The B-1100 Series: WHAT'S NEW?

B-1100 Series Workboard Faucet ENHANCEMENTS

B-1100

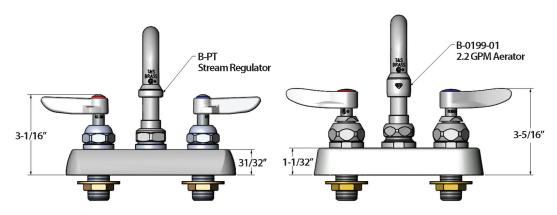
- B-0199-01 (2.2 GPM) aerator replaces the B-PT stream regulator
- B-1100 series outlet is now a water-saving aerator

• New, distinctive design

B-1100 faucets now use B-1100 Eterna cartridges, or the option of B-1100 Cerama cartridges (on select B-1100 models)

- A sturdy, reinforced escutcheon
- Change includes all three sizes of workboard faucets: 3½", 4" and 8" C/C

- Heavy-duty forged brass faucet bodies redesigned for T&S cartridges
- No longer uses spindles with threaded bodies and removable seats
- Easier to maintain and install replacement parts

New streamlined design of lever and wrist-action handles

Hot and cold indexes have a new, clean look to complement new handles

New design, same look as bonnet and swivel nut

New design, same look as bonnet and packing nut
